ADDENDUM NO. 1

REROOFING AND ELEVATOR LOBBY IMPROVEMENTS AT KALANIHUIA

HPHA JOB NO. 09-011-124-F

DECEMBER 2009

TYPICAL RENOVATED ELEVATOR LOBBY DETAIL REFLECTED CEILING PLAN

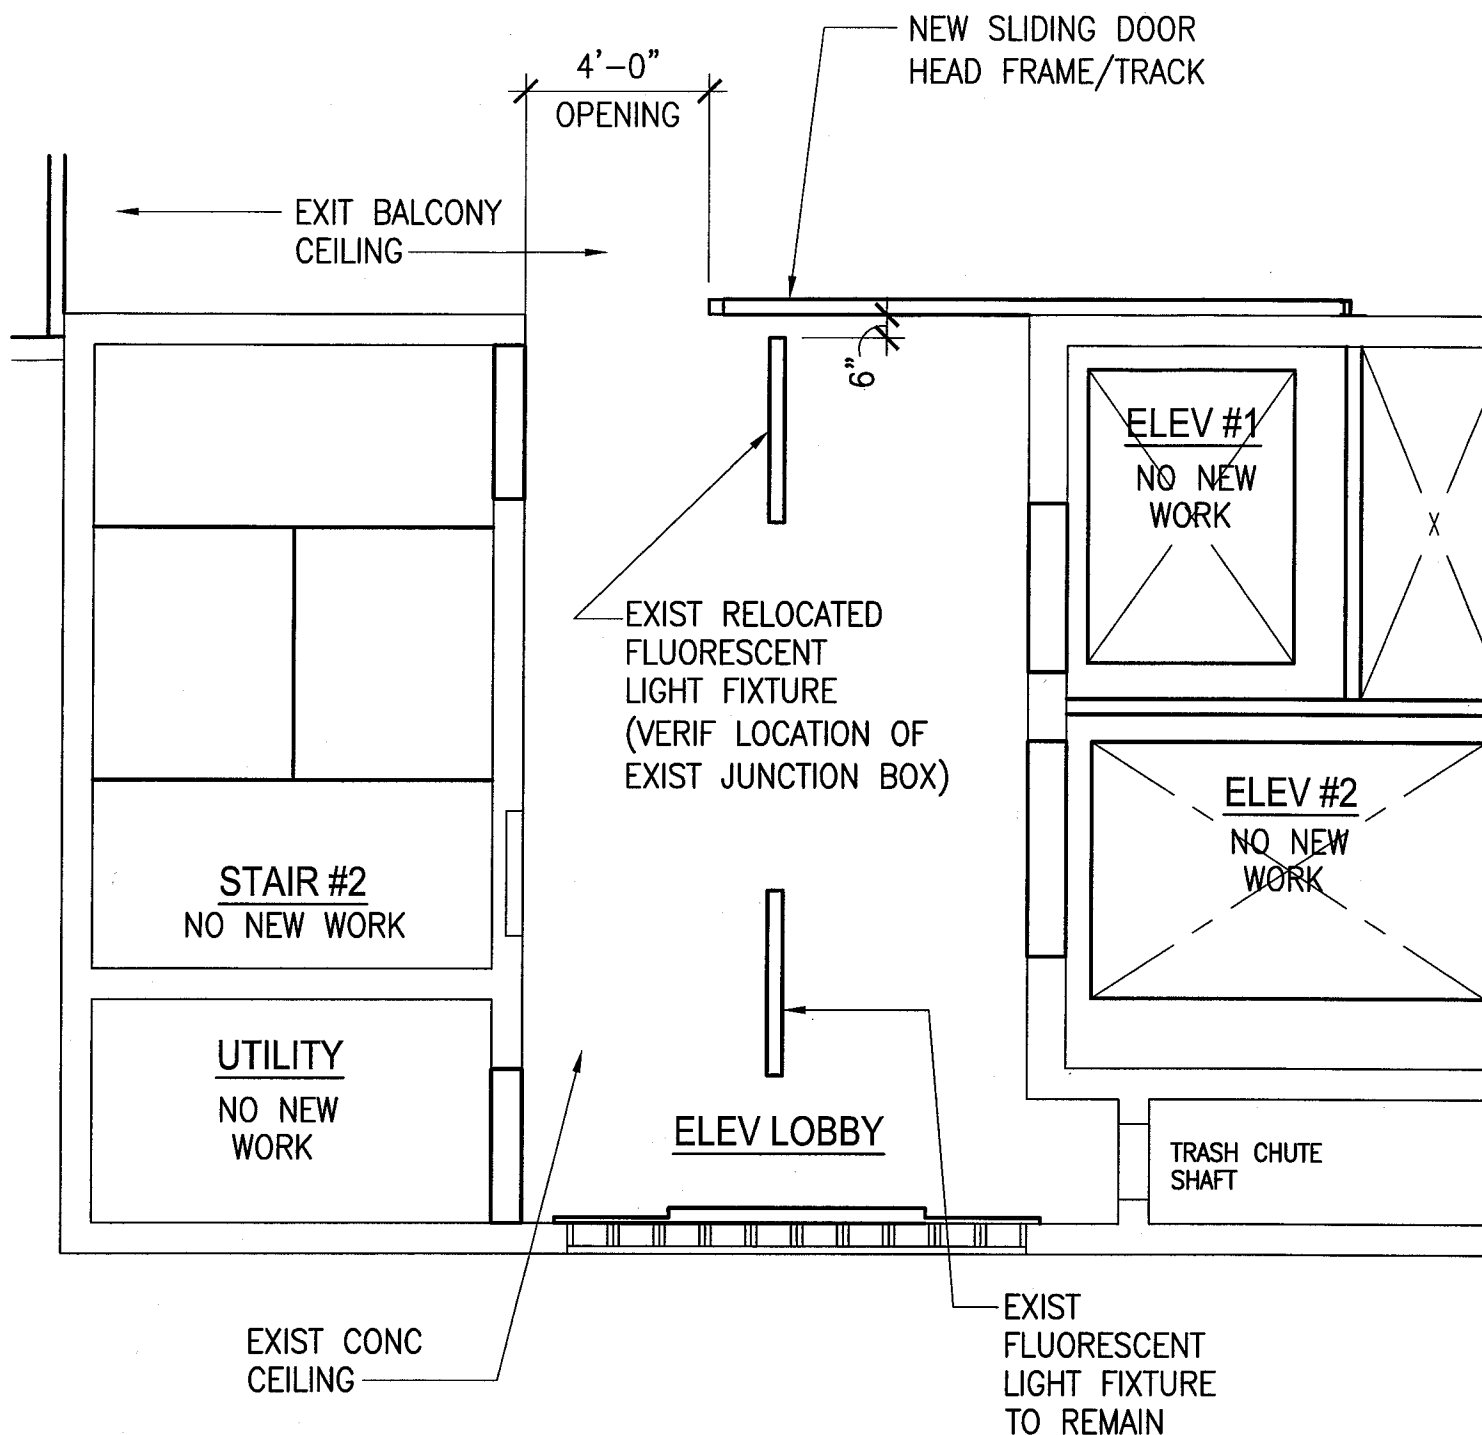
1. Plan Sheet No. A-3

- a. See attached SK sheets for revised drawings.

TYPICAL ROOF TO WALL BASE FLASHING

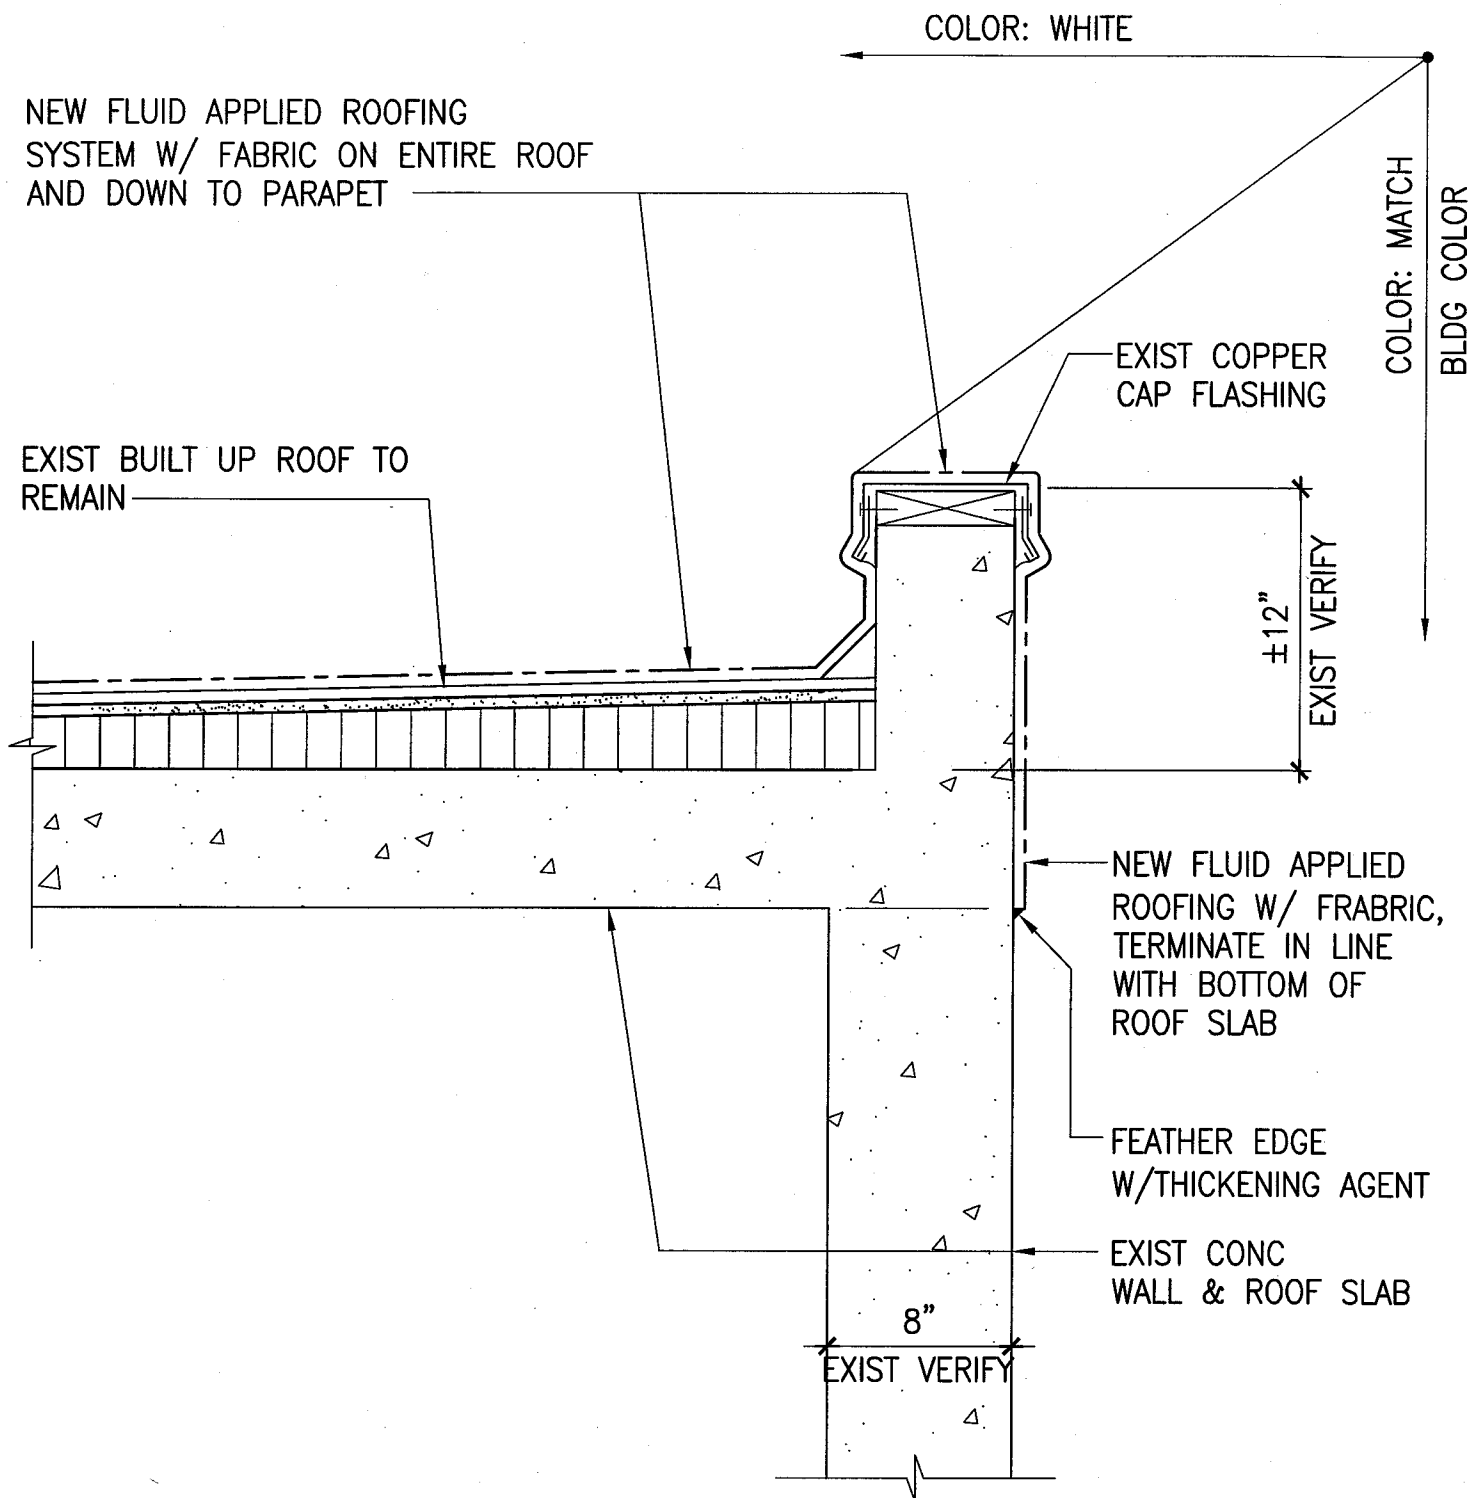
- d. Detail Plan 2/A-4 Boiler Room Floor/High Roof Renovated Plan: Delete note: "NEW EXTERIOR BOARD AND FRAMING IN FRONT OF EXISTING CMU SCREEN BLOCKS".
- 3. Plan Sheet No. A-5 (Narrative changes, new drawings will not be issued).
 - a. Sections A/A-5 and B/A-5: Delete "NEW BUR ON TAPERED INSULATION" and replace it with the following: "APPLY ONLY FLUID APPLIED ROOFING SYSTEM WITH FABRIC PER SPECS ON EXISTING ROOF/FLOOR AND AT EXISTING TRASH CHUTE AND WATER HEATER FLUE SHAFT WALLS AS INDICATED".
- 4. Plan Sheet No. A-6, A-7 & A-8
 - a. See attached SK sheets for revised drawings.

DOOR ELEVATION

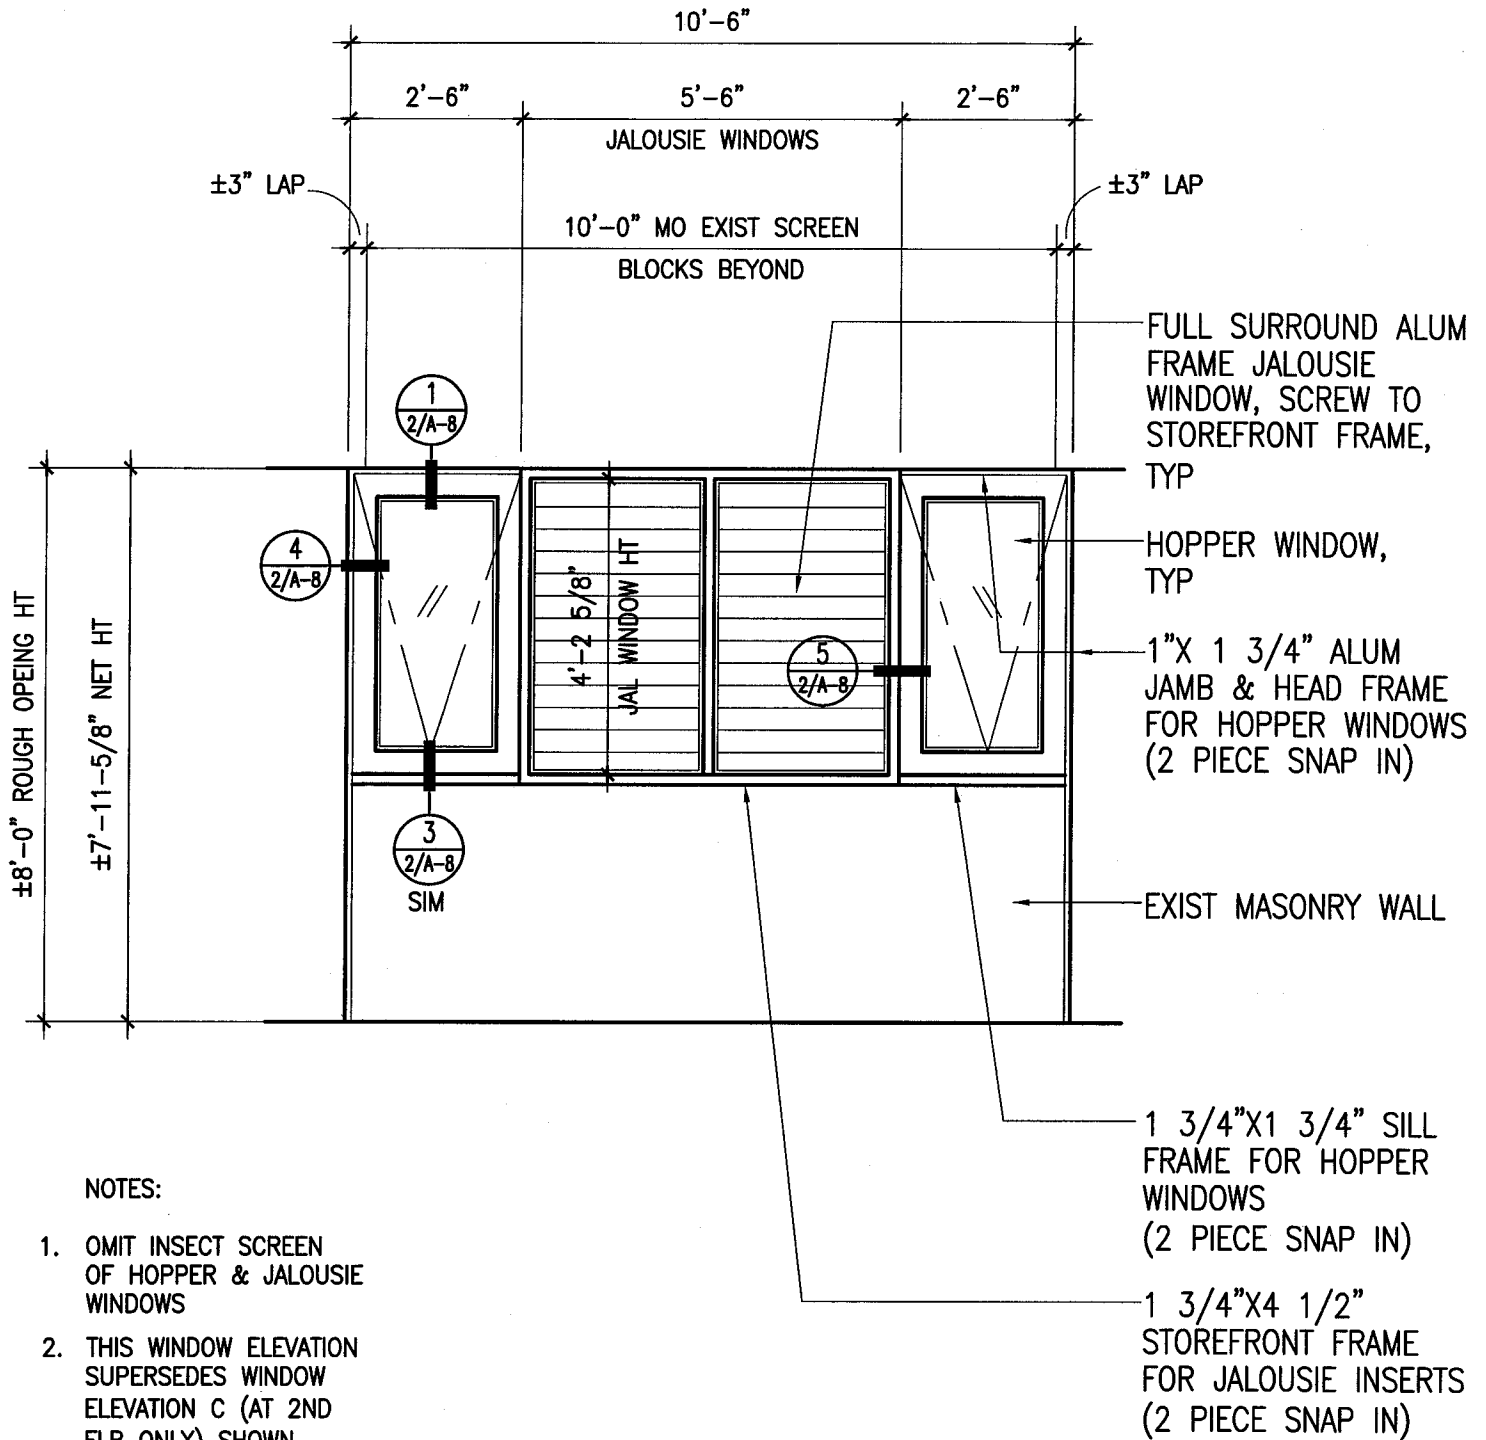
THIS DOOR ELEVATION
SUPERSEDES DOOR
ELEVATION A SHOWN
ON SHEET A-3 &
DOOR ELEVATION
SHOWN ON SHEET
A-8

WINDOW ELEVATION
NOT TO SCALE

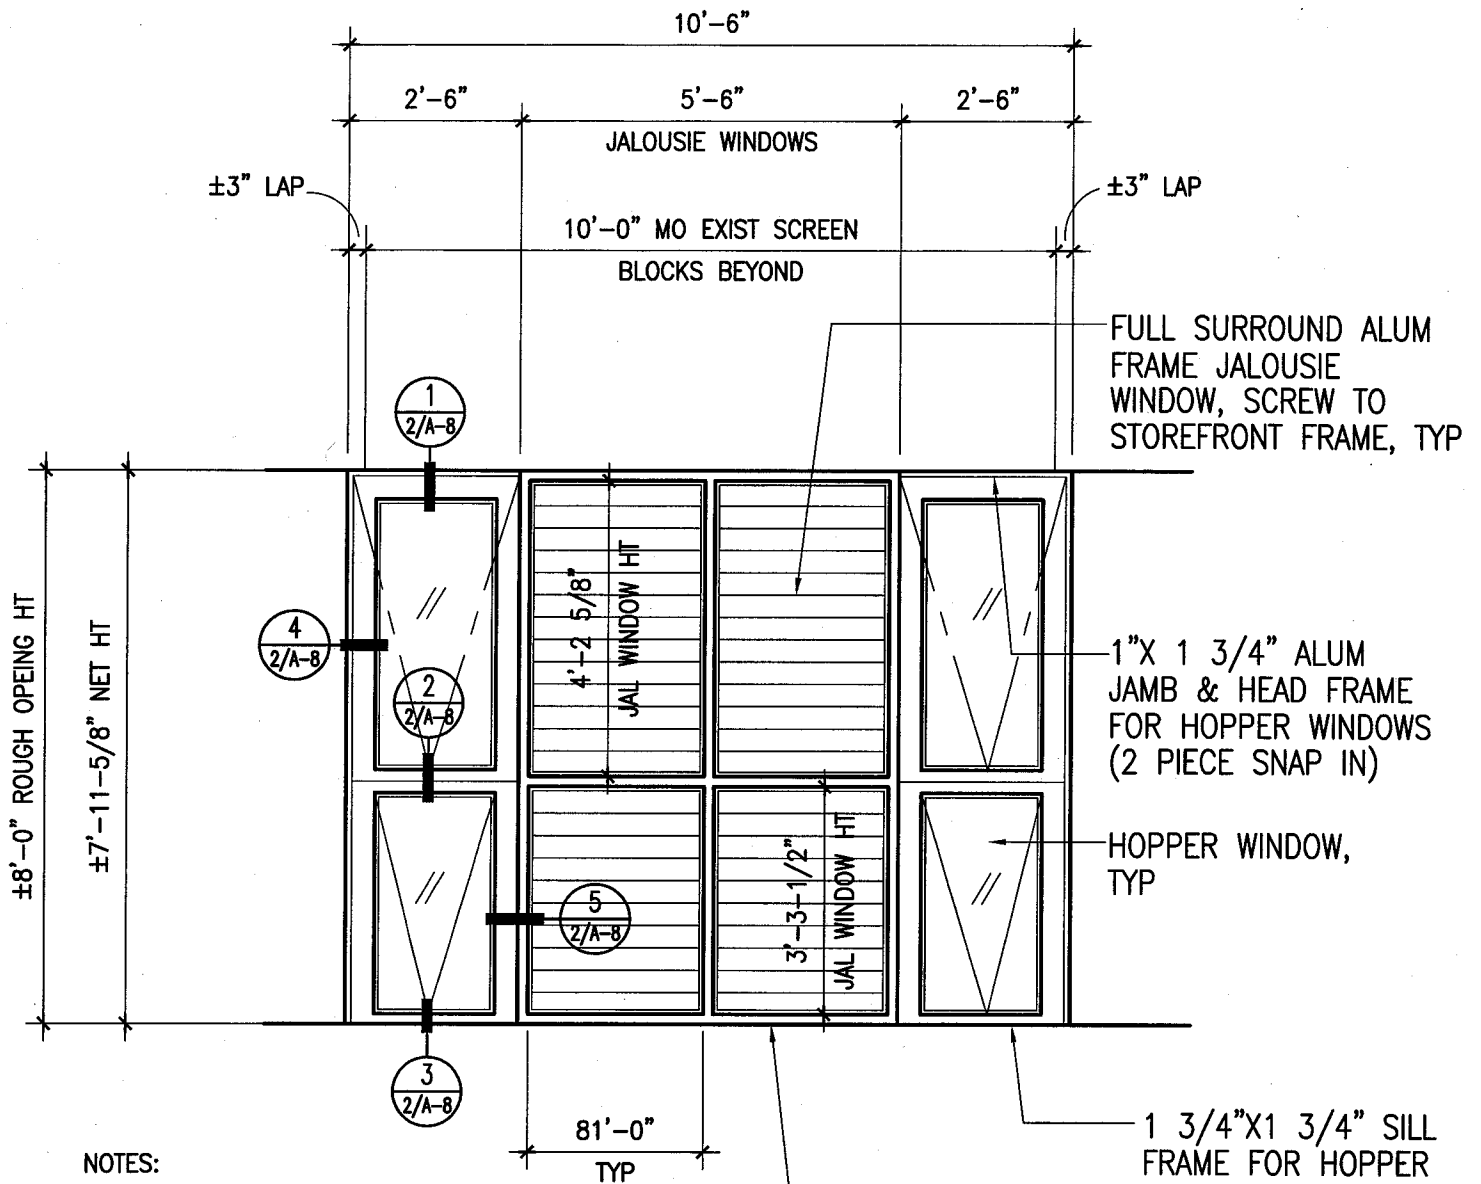
1. OMIT INSECT SCREEN OF HOPPER & JALOUSIE WINDOWS
2. THIS WINDOW ELEVATION SUPERSEDES WINDOW ELEVATION C (AT 2ND FLR ONLY) SHOWN ON SHEET A-3
3. COORDINATE JALOUSIE WINDOW SIZE WITH WINDOW MANUFACTURER

WINDOW ELEVATION

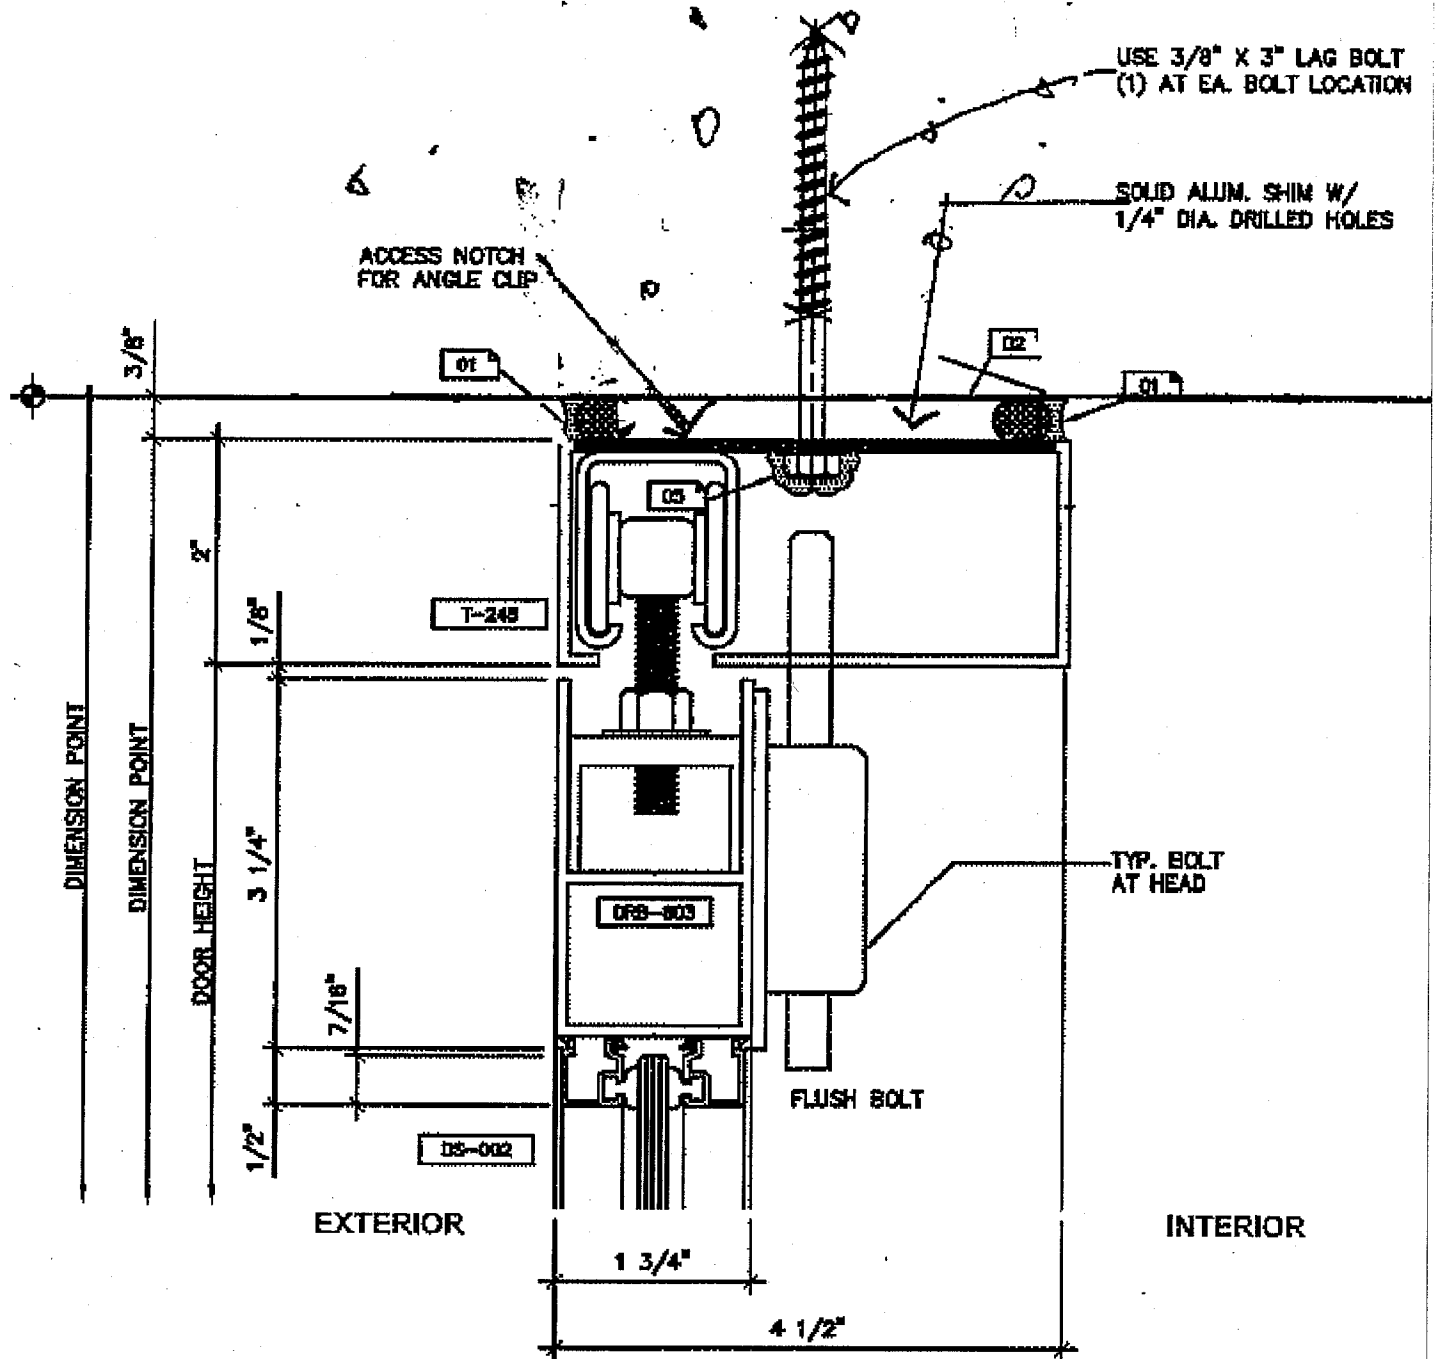
1. OMIT INSECT SCREEN OF HOPPER & JALOUSIE WINDOWS
2. THIS WINDOW ELEVATION SUPERSEDES WINDOW ELEVATION C SHOWN ON SHEET A-3 & WINDOW ELEVATION SHOWN ON SHEET A-8
3. COORDINATE JALOUSIE WINDOW SIZE WITH WINDOW MANUFACTURER
